AGENDA
CITY OF LAKE WORTH BEACH
HISTORIC RESOURCES PRESERVATION BOARD REGULAR MEETING
CITY HALL COMMISSION CHAMBER
WEDNESDAY, SEPTEMBER 14, 2022 -- 6:00 PM

MEMORANDUM DATE: June 28, 2022

TITLE: **HRPB Project Number 22-00100250:** Consideration of a Certificate of Appropriateness (COA) for door replacement for a single family house located at 432 South L Street; PCN# 38-43-44-21-15-157-0010. The subject property is a contributing resource within the Southeast Lucerne Historic District and is located in the Single Family Residential (SFR) zoning district. The future land use designation is Medium Density Residential (MDR).

Exhibit 1 – View of Subject Property

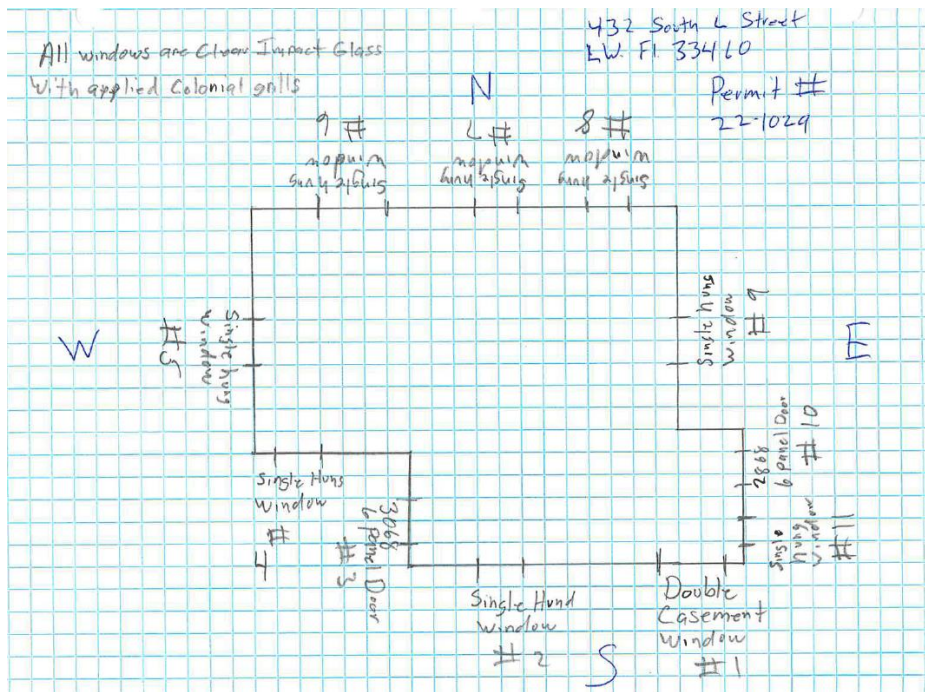
Staff Analysis: Based on the City’s Historic Preservation Design Guidelines, staff contends that the proposal is *unsuccessful* in replicating an appropriate door design for a Wood Frame Vernacular structure.

Staff Analysis: Per the regulations set forth in the City’s Historic Preservation Design Guidelines, replacement doors shall replicate their original appearance. The proposed door, according to the Historic Preservation Design Guidelines, is not appropriate to the architectural style.

Staff Analysis: The proposed door does not comply with the City's Historic Preservation Design Guidelines. Therefore, the project is not visually compatible with neighboring properties.

Staff Analysis: The proposed door seeks to match the design of the existing door, which is not compatible with the Wood Frame Vernacular architectural style of the building.

STAFF RECOMMENDATION: Staff recommends that the Board discuss and clarify the use of raised six panel doors versus recessed six panel doors for Wood Frame Vernacular homes. Current Design Guidelines

Exhibit 2 – Proposed Additions

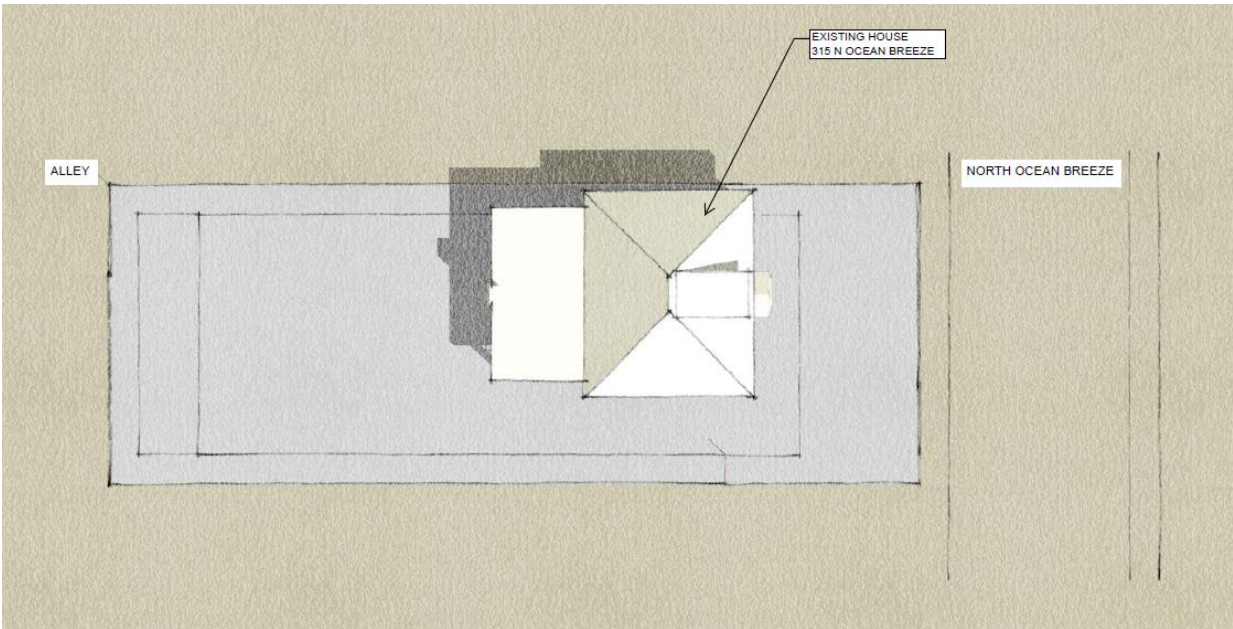
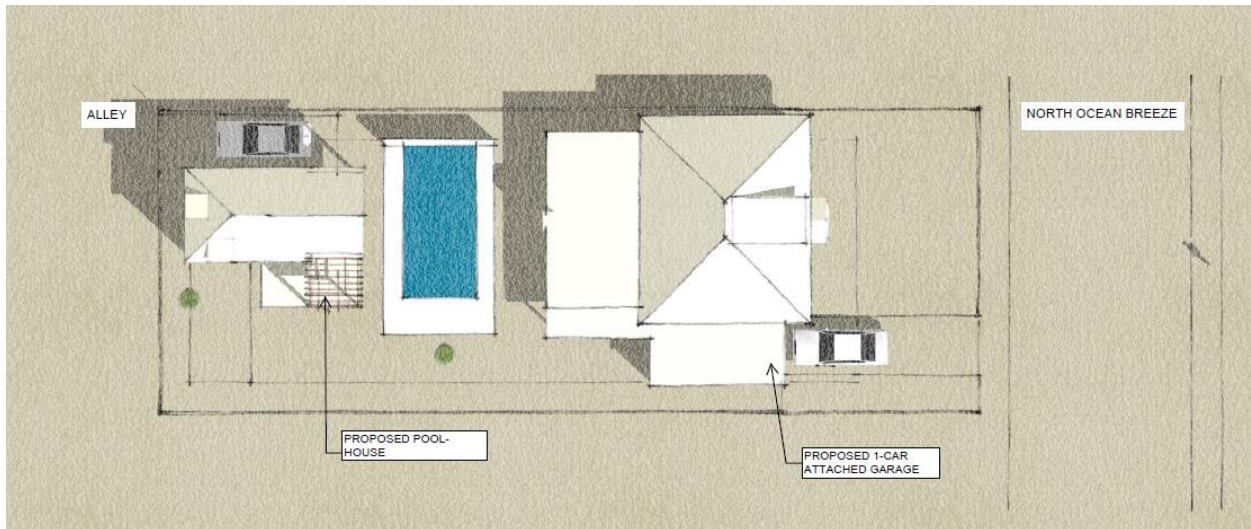
STAFF RECOMMENDATION: Staff recommends approval of the proposed exterior alterations and new construction. The proposed single car garage, loggia, and new 2-story accessory building is designed with materials and detailing that are consistent with the existing structure. With these criteria in mind, staff contend that these modifications are successful in complying with the City’s design guidelines and historic preservation ordinance. However, staff recommends the removal of the lattice-roof balcony on the south end of the proposed accessory structure, as this portion of the balcony is visible from the

street and contributes to the accessory structure exceeding the 40% limit imposed in the Land Development Regulations.

Staff Analysis: The proposed single car garage, loggia, and new 2-story accessory building are designed with material and detailing that differentiate from, but are compatible with, the existing structure. With these criteria in mind, staff contend that these modifications are successful in complying with the City’s design guidelines and historic preservation ordinance. However, staff recommends the removal of the lattice-roof balcony on the south end of the proposed accessory structure, as this portion of the balcony is visible from the street and contributes to the accessory structures exceeding the 40% limit imposed in the Land Development Regulations.
